# DRAINAGE LETTER

**Lot 12 - Rolling Thunder Business Park  
10707 Maltese Pt.  
Peyton, Colorado**

**SK Project No. 24-105**

**April 11, 2024**

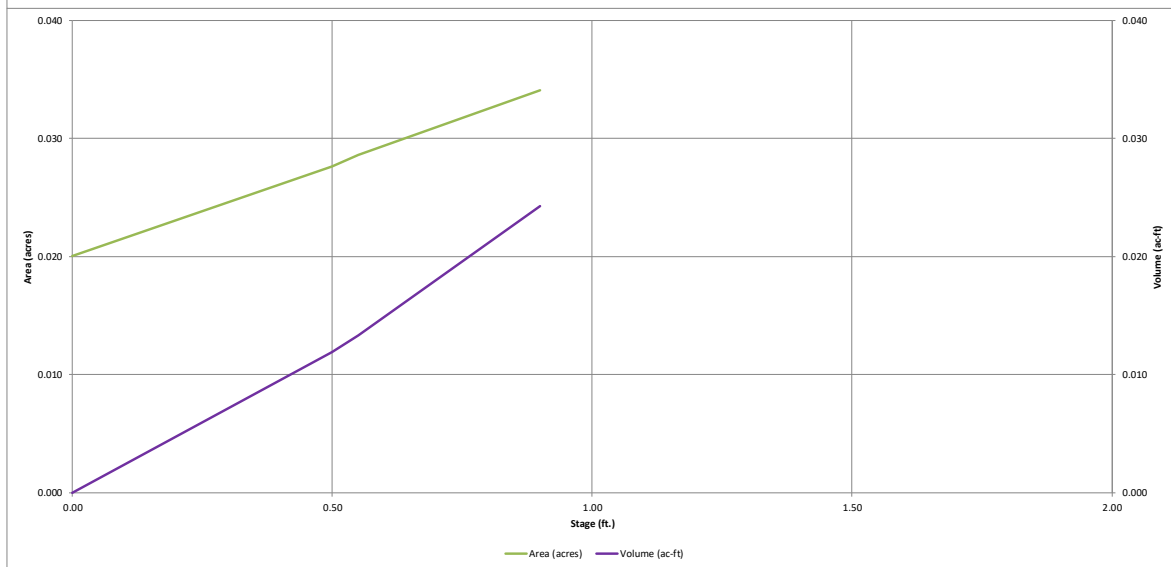
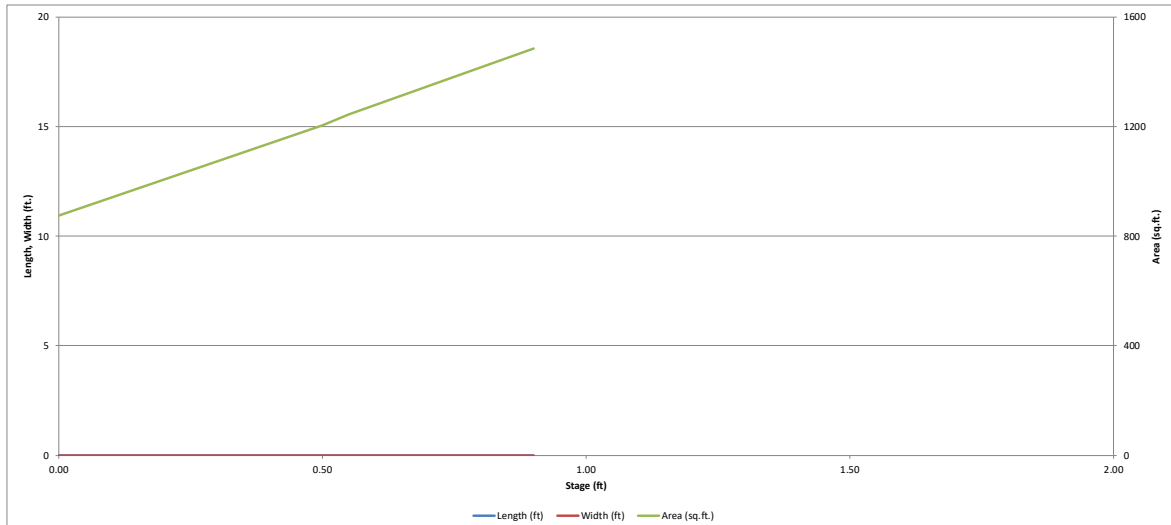
This worksheet is really only for determining full spectrum performance of an EDB, it would not be needed for this project.

Worksheet has been removed from the drainage letter. -SKDG

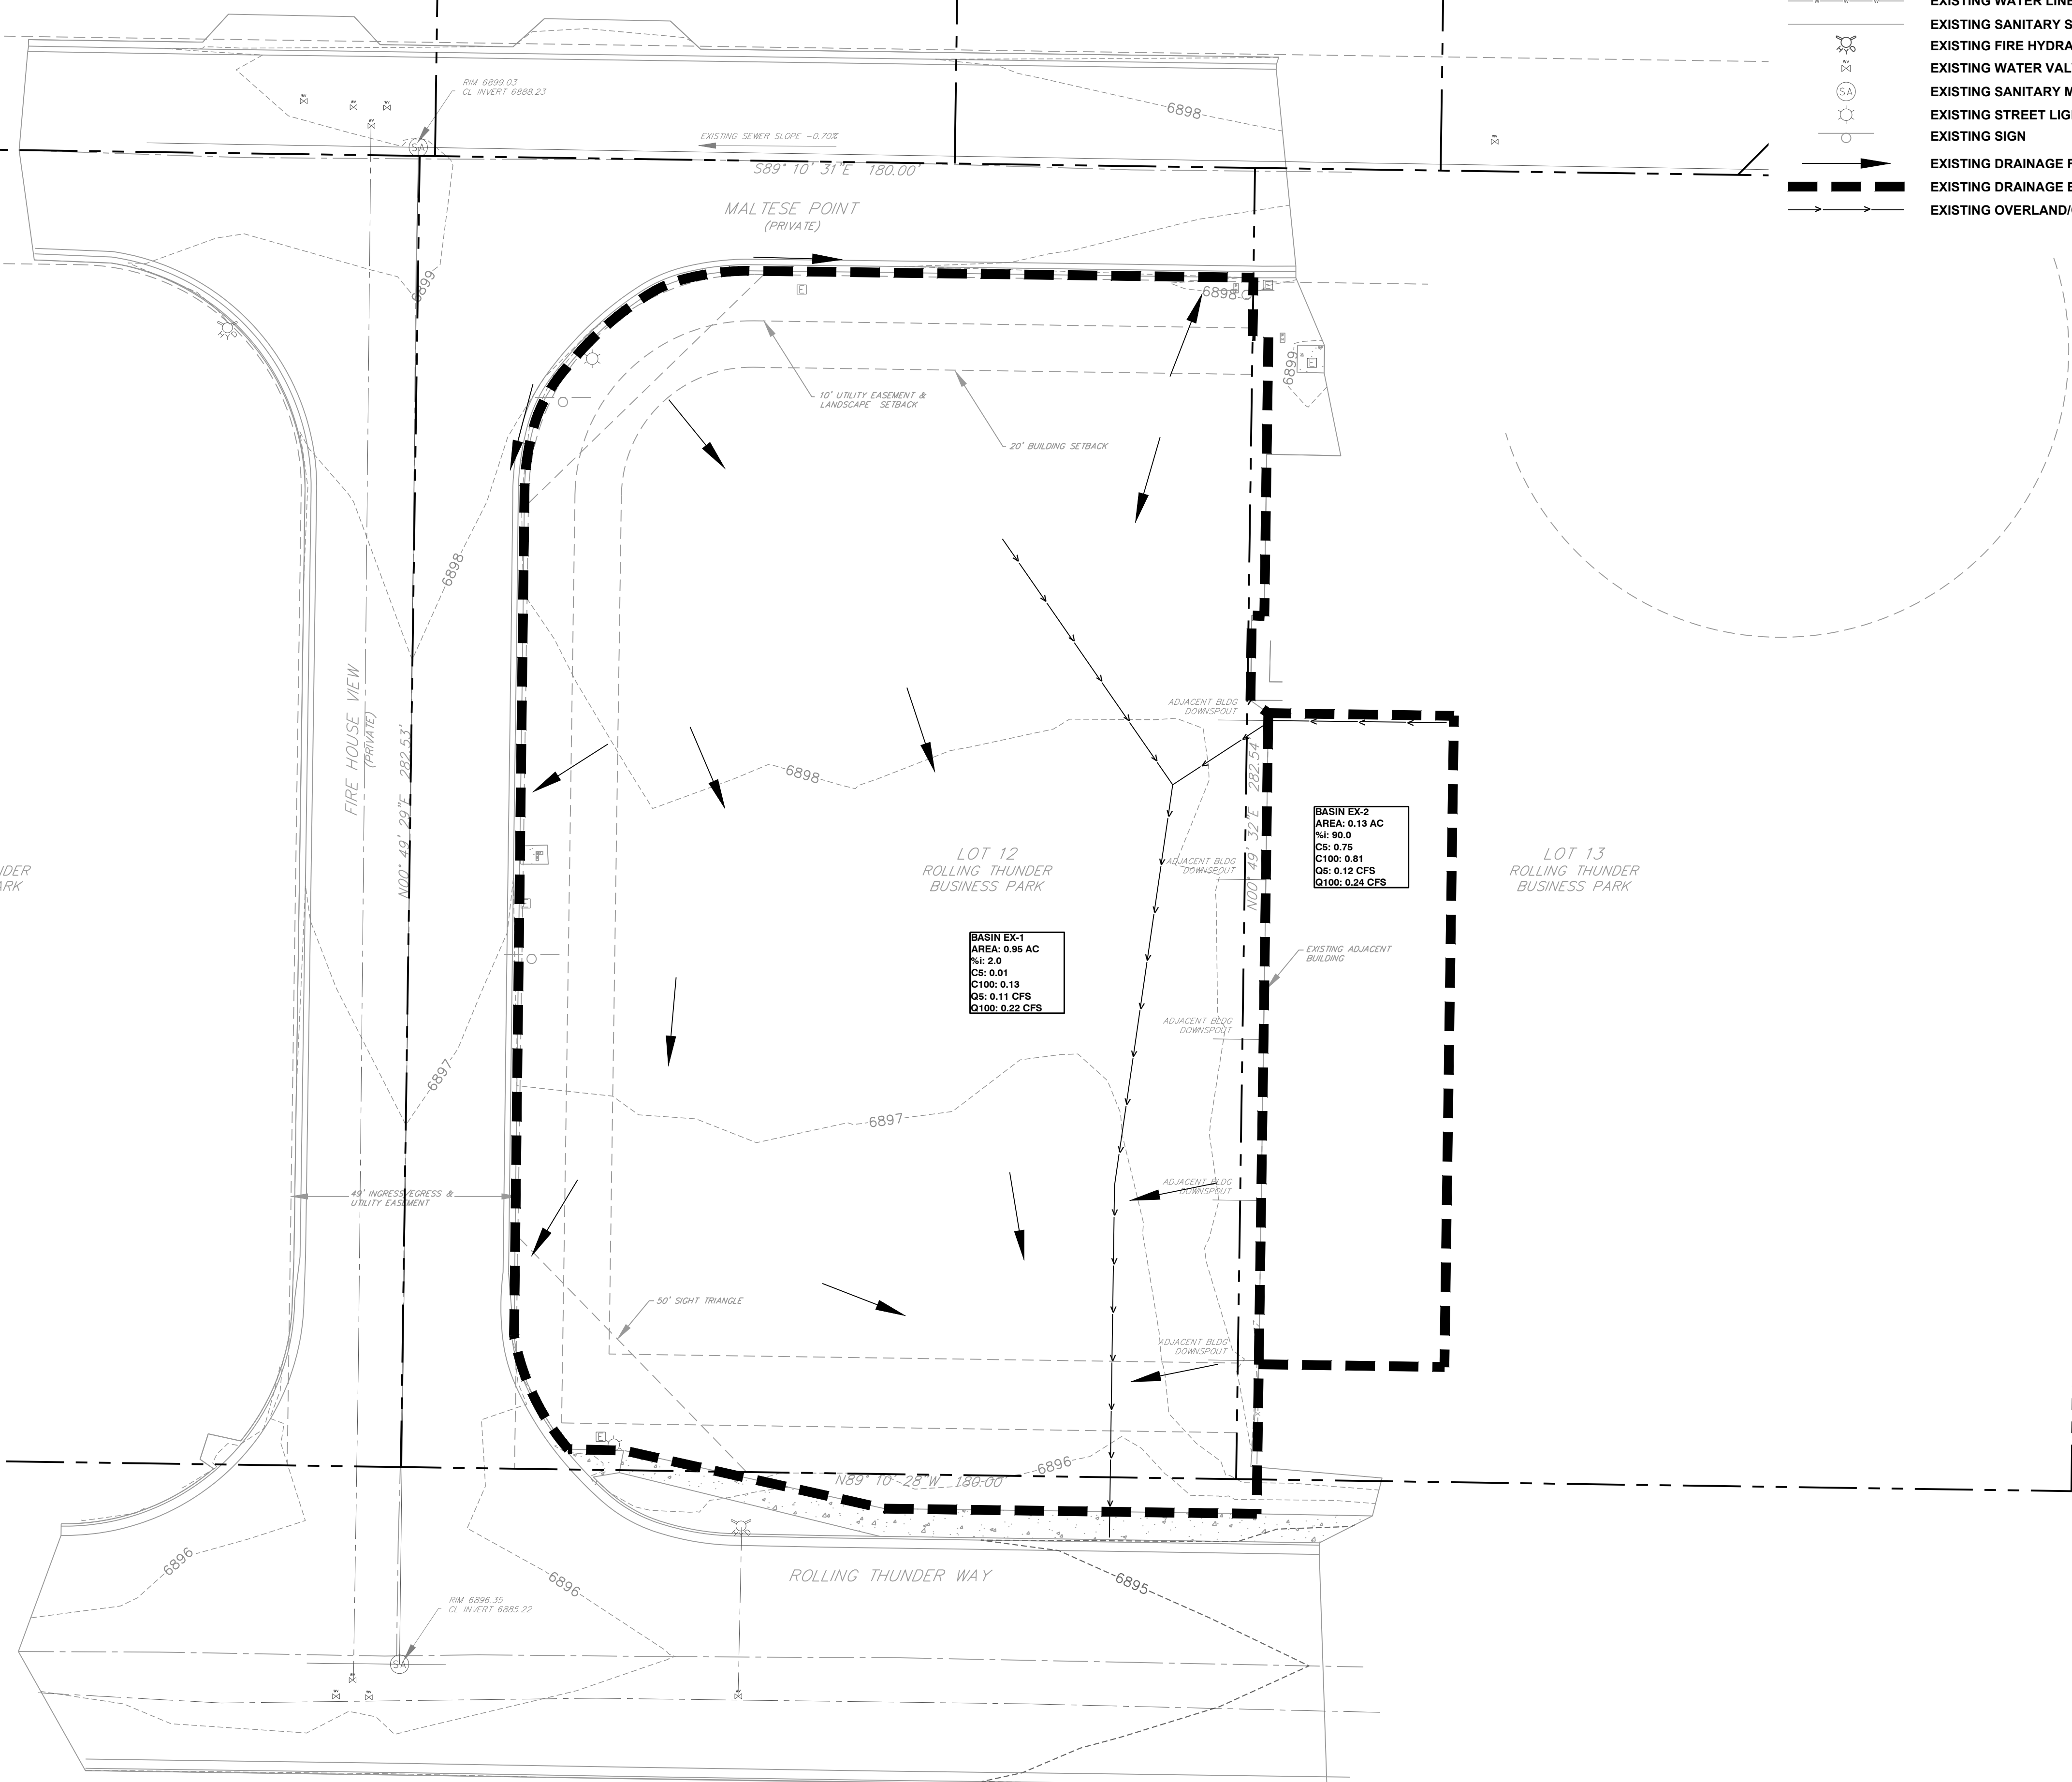
Please move these to  
the end of the report

Appendix F has been  
relocated. -SKDG
